**State of Oregon
Department of Environmental Quality**

Memorandum

Subject: ARCADIS's April 2012 report establishing Upper Prediction Limits for the Lockheed Martin Hazardous Waste Post-Closure Permit.

Figure 1: MW-37S Sulfate

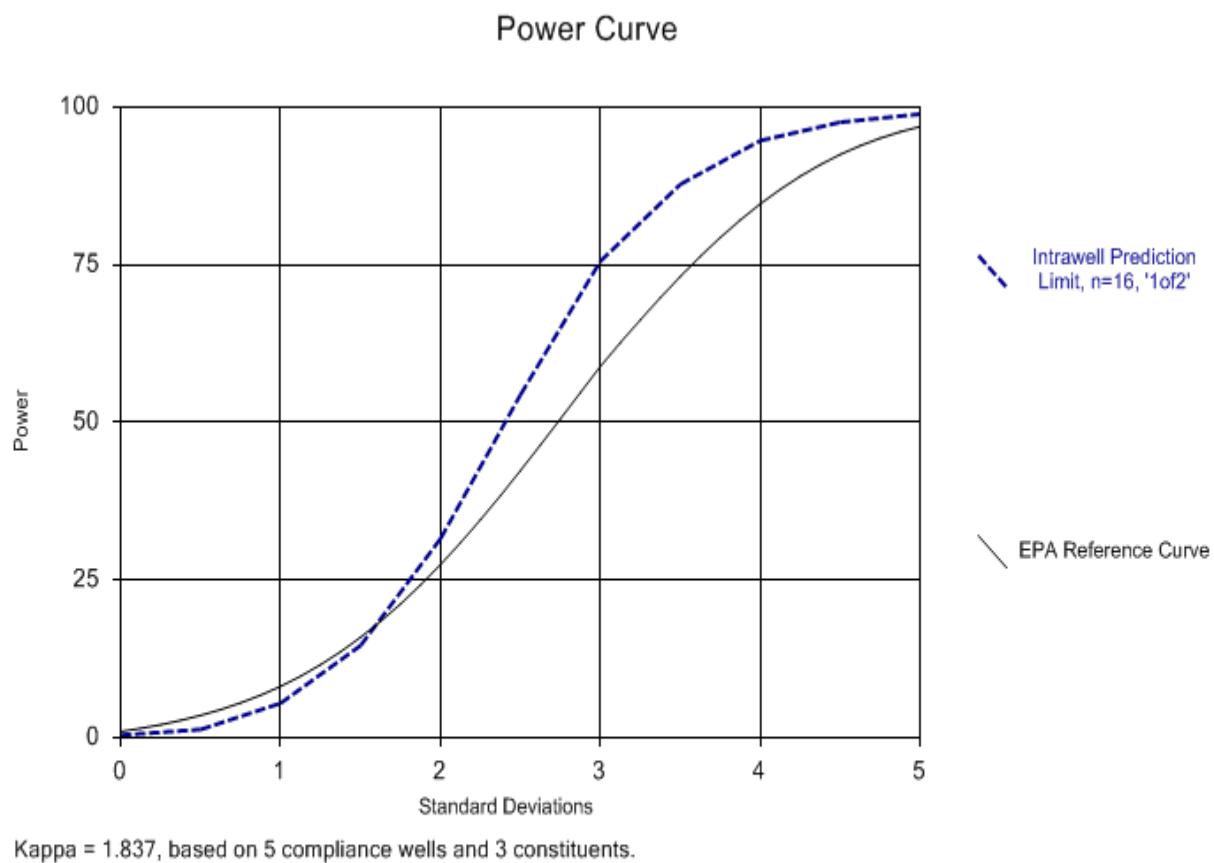
I computed a series of example power curves as spot check of the ARCADIS results. In each case, the resulting power curve met or exceeded the specific standard as indicated by ARCADIS. Four examples are presented below.

The approach described by ARCADIS is good. I have no significant concerns with what they have done. I would request clarification for sulfate at MW-37. Why did they select the Wilson Hilferty (WH) UPL for Table 1? This is one of the higher gamma-UPLs in the group of 99% UPLs calculated by ProUCL. They had one high outlier in February 2011 that skews the distribution. It would seem based on the trend that a lower UPL would be more realistic in this case. I reproduce the UPL calculations using the data provided in the appendix.
